RANCHO SANTIAGO COMMUNITY COLLEGE DISTRICT

ADDENDUM NO. 1

Bid #1384

Purchase of Engineering Equipment for the New Science Center at Santa Ana College

ATTACHMENT A

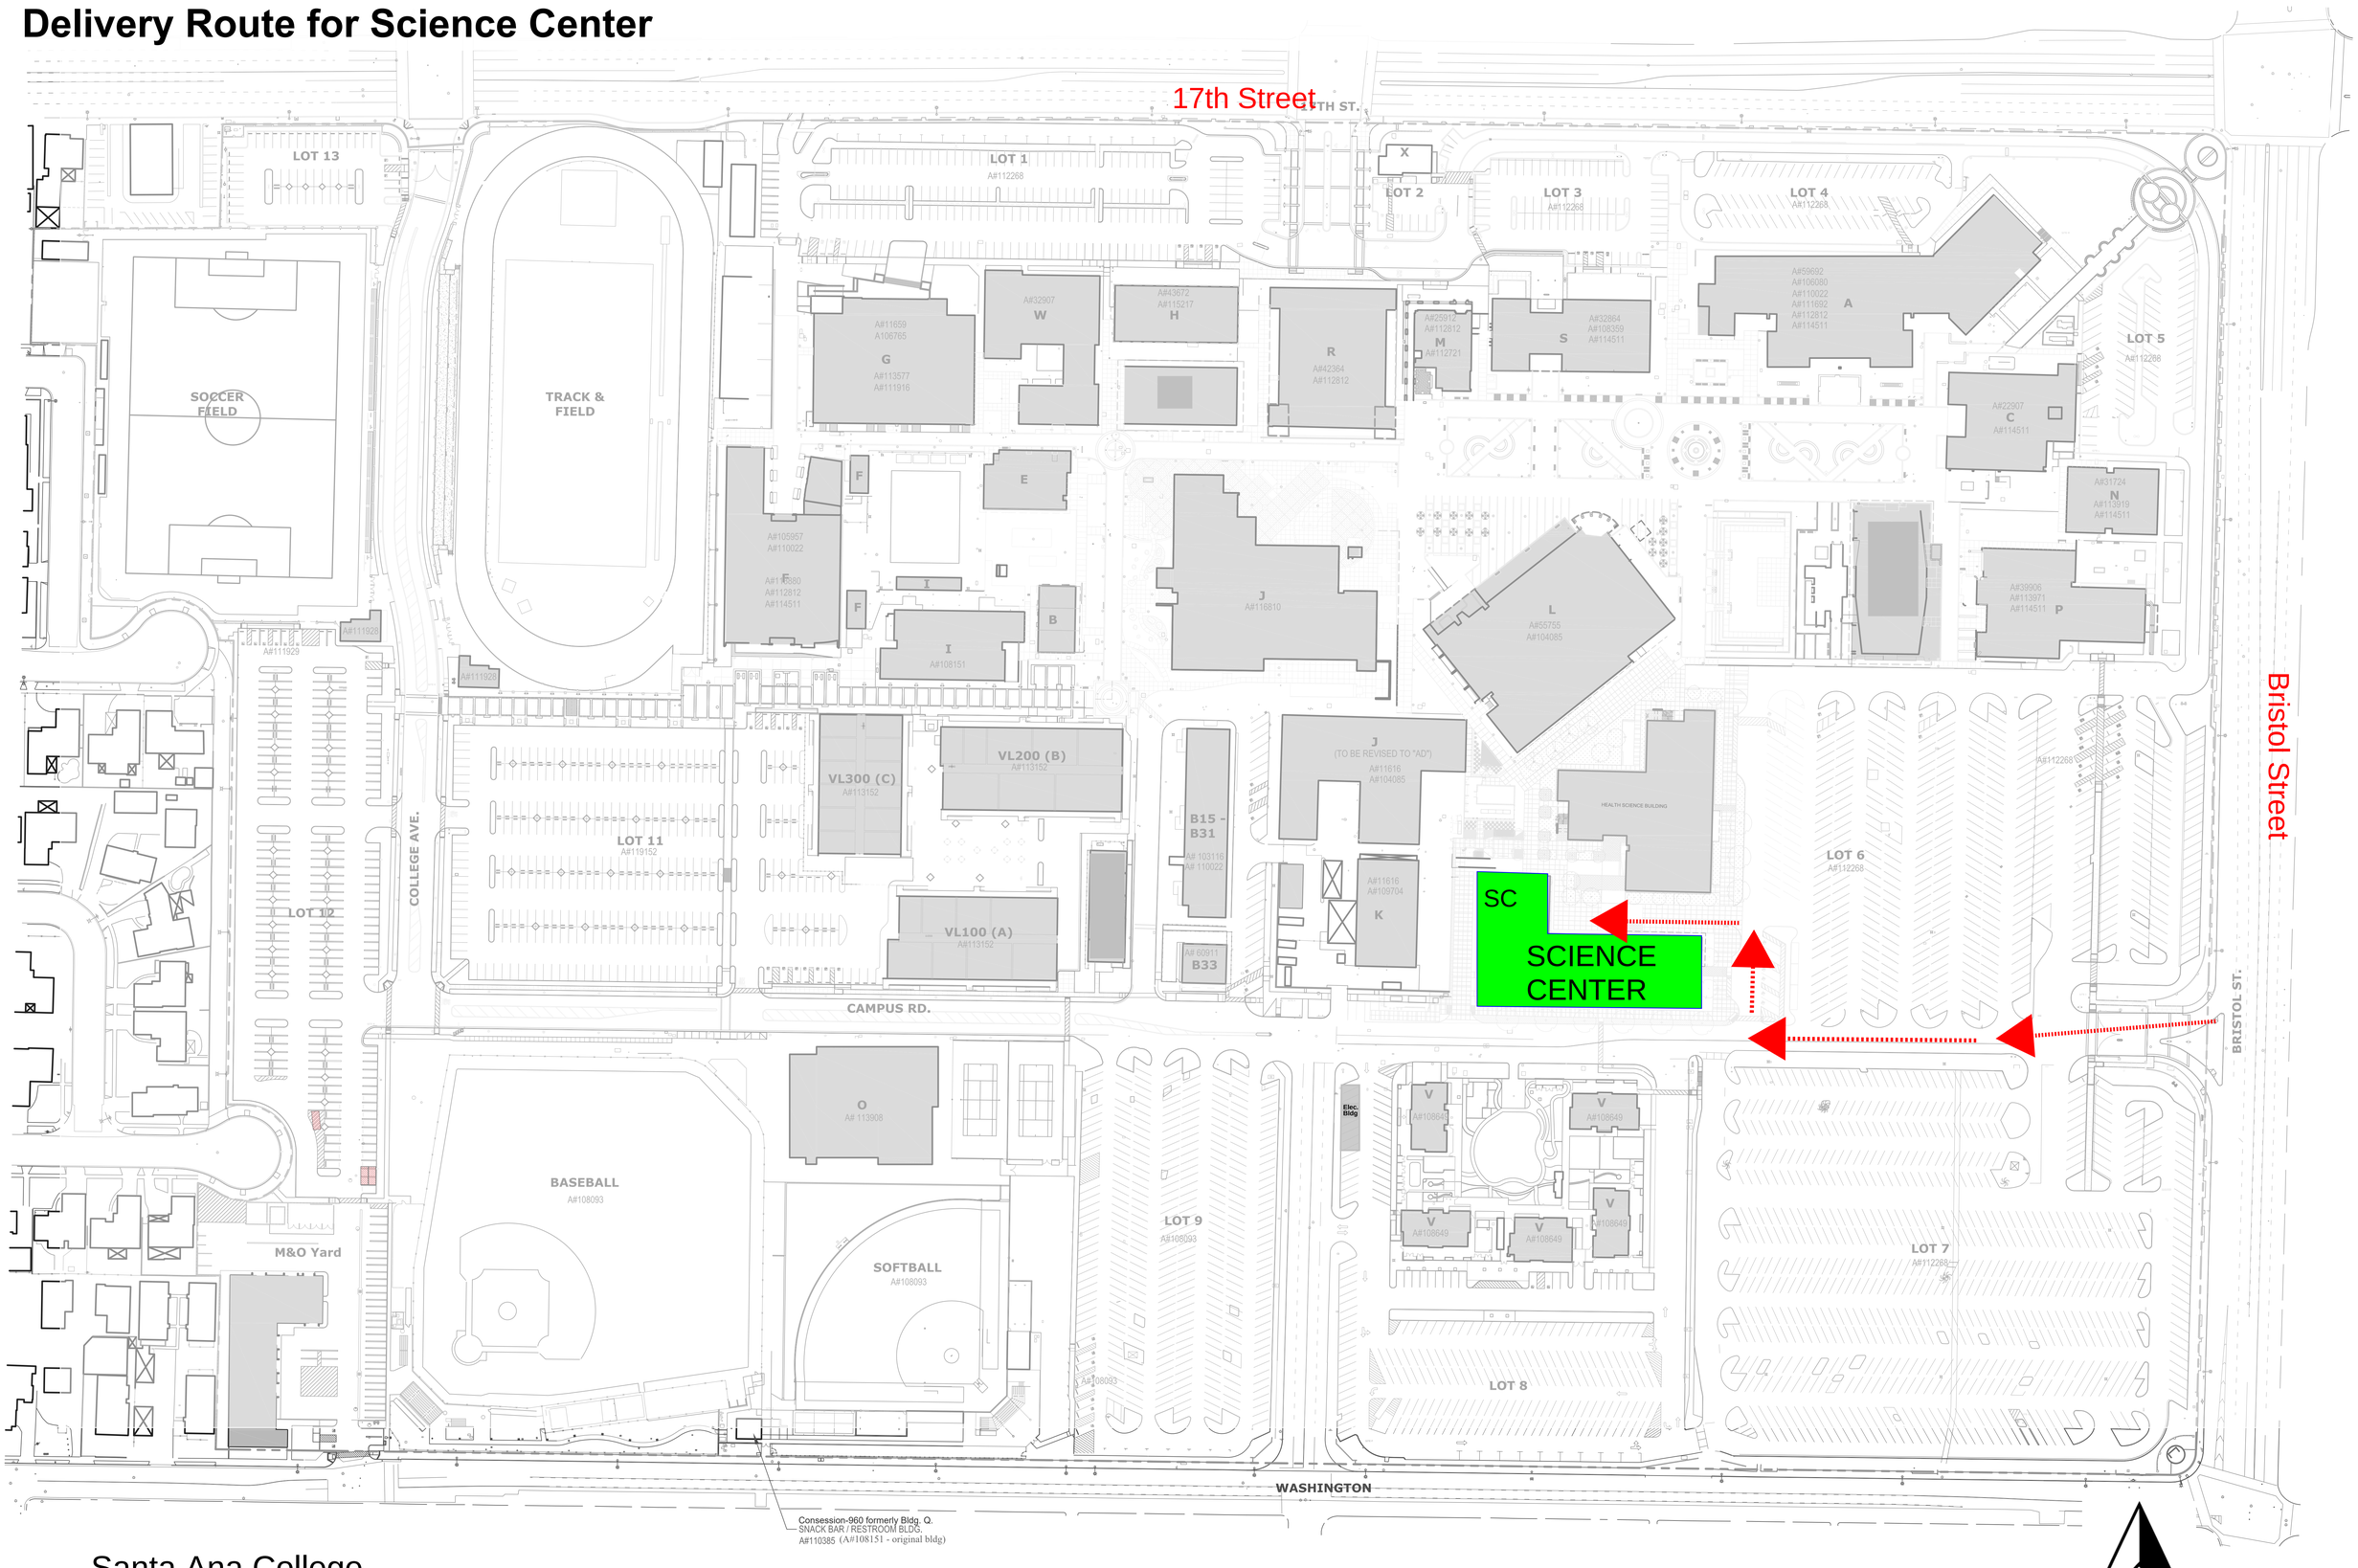
Question:
Can you tell me about the door entrance to the Delivery location. What are the dimension of the entrance / door. It is easy access to get the machine in? Can we take a forklift in the building. Does anything else have to be moved to get the machine in? I need to know this information for quoting the freight / rigging.

Answer: Please refer to **Attachment A** regarding path of travel for delivery to the engineering lab. Refer to **Attachment B** for the floorplan, mechanical, electrical, and door schedule information. When reviewing door schedule information vendor shall allow for width reduction of 1-1/2" for door leaves. Refer to **Attachment C** for equipment layout information. A forklift cannot enter the building, but a pallet jack would be able to enter the building/lab. Path of travel to the location of delivery will remain clear/open. Relocation of other existing furniture/equipment to place unit(s) is not anticipated.
